Thursday, 3/8/2007 1:15:34 PM Kim Johnston **Process Sheet** : BRACKET **Drawing Name** : CU-DAR001 Dart Helicopters Services Customer : 31120 Job Number : 10809 **Estimate Number** : D3177043 **Part Number** P.O. Number · D3177 REV B2 : 3/8/2007 S.O. No. : **Drawing Number** This Issue : N/A : NC Project Number Prsht Rev. : MACHINED PARTS : B2 : // **Drawing Revision** Type First Issue : 24883 Material Previous Run : 4/1/2007 **Due Date** Written By Checked & Approved By B 03.01.27 Added Step 12 KJ/RF Comment **Additional Product** Job Number: Description: Machine Or Operation: Seq. #: 6061-T6 Bar 1.0" x 12.0" 1.0 M6061T6B1000X12000 Comment: Qtv.: Total: 8.3124 f(s) 4.1562 f(s)/Unit 6061-T6 Bar 1.0" x 12.0" Material: 6061-T6 (QQ-A-200/8) or (QQ-A-250/11) 1.00" thick (M6061T6B1.000x12.000 or M6061T6S1.000) M9601 Batch BAND SAW BAND SAW 2.0 Comment: BAND SAW Cut blank: 47.40" x (12.000" +0.100/-0.000) HAAS CNC VERTICAL MACHINING #1 3.0

Subject: RE: D3177 Parts not made to drawing

Apparently, production has made a couple D3177-041 and D3177-043 Brackets with incorrect dimensions. The 0.970" thickness dimension was cut too short, to approximately 0.945". I've been punching the new n

\	DESIGN	DRAWN BY		ROSPACE LTD r, ontario, canada
7	CHECKED	APPROVED 🚜	DRAWING NO.	REV. B
	#	-	D3177	SHEET 3 OF 3
	DATE		TITLE	SCALE
	03.01.07		BRACKET	1:1

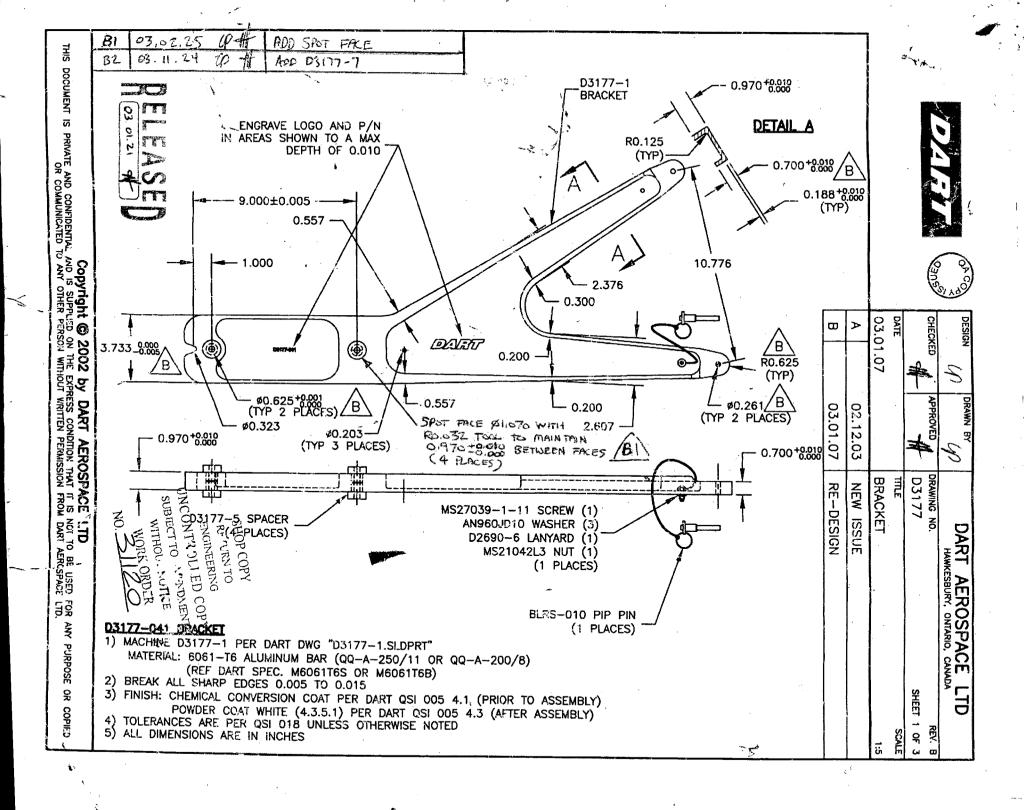
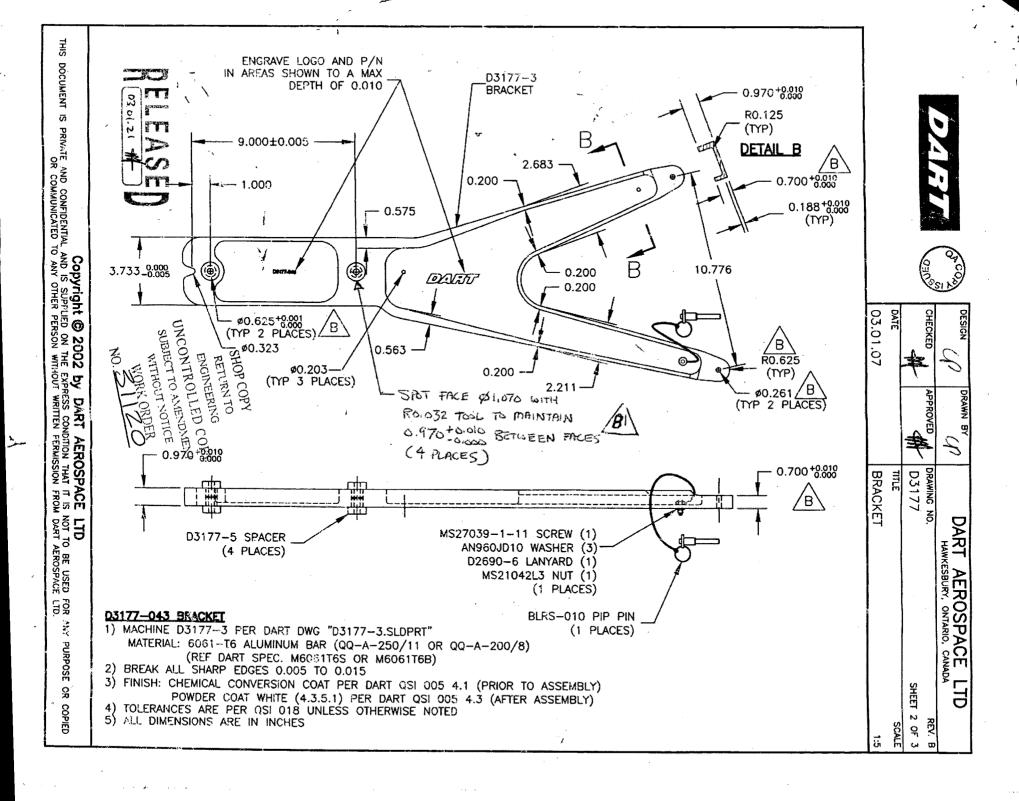
Section C-C is the critical section for both parts. Using 0.945", and the method shown in SR-D130-701-1, the parts will yield (see Stress Analysis.pdf), so it looks like they are unacceptable, but I think the analysis is a little too conservative.

If you look at the calculations in Section 6.0 of the stress report you can see that 30" was used as the moment arm for Section C-C (distance from the section to the centroid of the bracket plus basket area), while Section A-A and Section B-B both used different (smaller) moment arms (from the section to the mounting hole). If you calculate the stress at Section C-C using a similar moment arm as A-A and B-B (from the section to the mounting hole, see Stress Analysis.pdf) the margin of safety is positive and acceptable. I don't see why a moment arm of 30" was used for Section C-C (except for being extra conservative) since the basket is not bending and the load on the part is actually applied to the mounting holes.

Do you think this deviation is acceptable or should the parts be scrapped?

Please scrap all D3177 parts.

I'm not sure I agree with your assessment. Besides, I don't have the authority to change the analysis. Therefore, the D3177-041/-043 parts that were cut to 0.945" should be scrapped.
